## SERVICE BULLETIN

<b>Reference number:</b>	<b>SB-10-0409V2</b>	<b>Issued: 06 June 2019</b>
<b>Subject:</b>	<b>Fuel Filling Problem</b>	
<b>Model(s):</b>	<b>DB9, DBS, Virage and Vanquish Volante</b>	
<b>VIN Range:</b>	<b>All</b>	
<b>Applicable to:</b>	<b>All Dealers</b>	
<b>Distribute to:</b>	<b>After Sales Manager</b> <b>Executive Manager</b> <b>Service Manager</b> <b>Sales Manager</b>	<b>Warranty</b> <b>Technician(s)</b> <b>Parts</b>

Figure 1

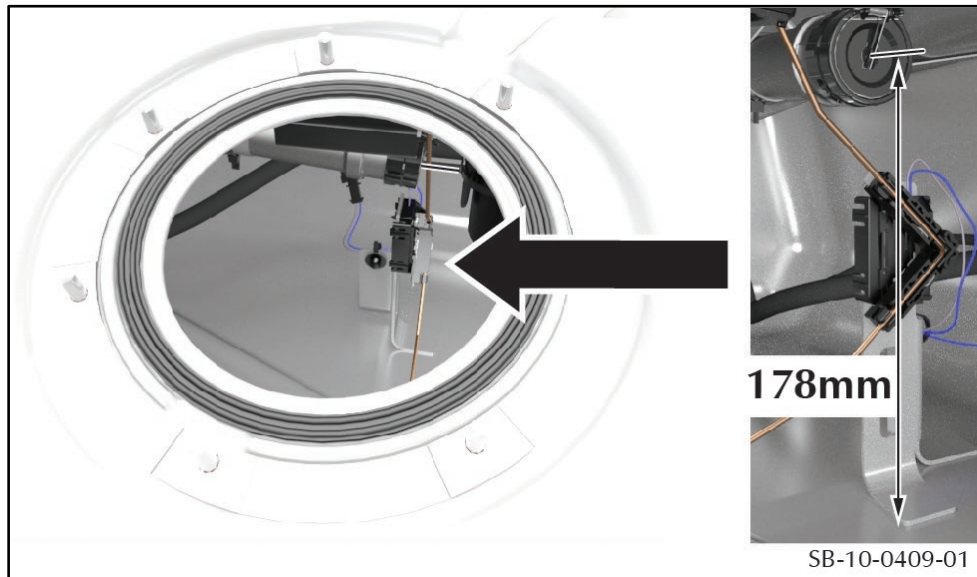
1. Drain the fuel tank (refer to Workshop Manual procedure 10.01.EA).
2. Measure the distance from the centre of the filling pipe inside the fuel tank to the bottom of the tank. Make sure that this distance is 178 mm (refer to Figure 1).

3. If the distance is not 178 mm, carefully bend the filling pipe inside the fuel tank and do step 2 again.
4. Make sure that the external tank filler neck (1) has a constant downward gradient. To do this, make sure that the damper casting (2) is in the highest position. Also make sure that the fuel filler neck to damper casting (3) is in the highest position (refer to Figure 2).

Figure 3

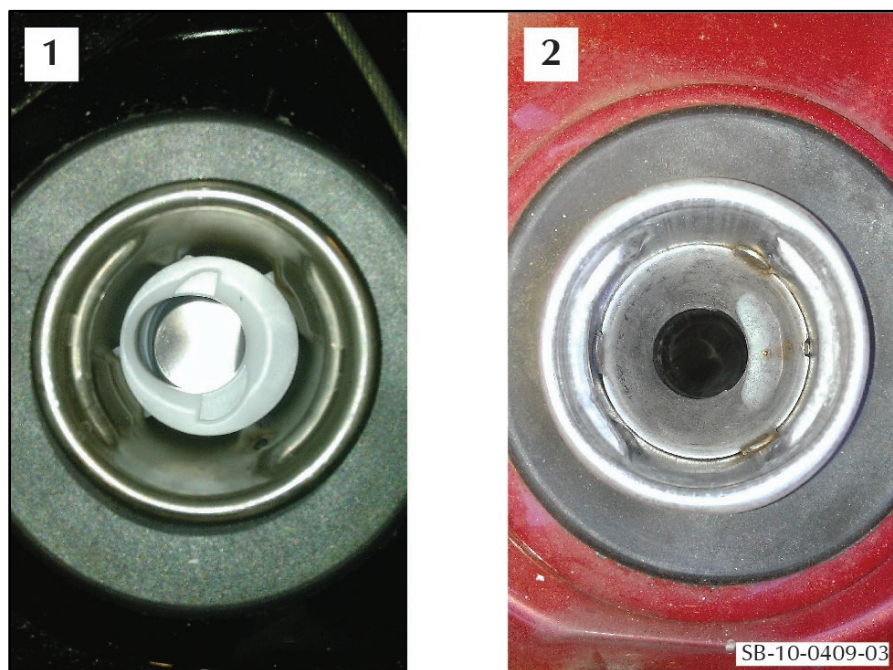
5. Install the access cover for the fuel tank (refer to the "Install" section of Workshop Manual procedure 10.01.AD).
6. Add fuel to the tank and make sure that the filling nozzle does not shut off frequently.
7. If the filling nozzle shuts off frequently, replace the existing fuel filler neck (1) with the replacement fuel filler neck (2) (refer to Workshop procedure 10.01.LC and Figure 3).

Description	Part Number	Quantity
Fuel Filler Neck	4G43-9034-BE	1
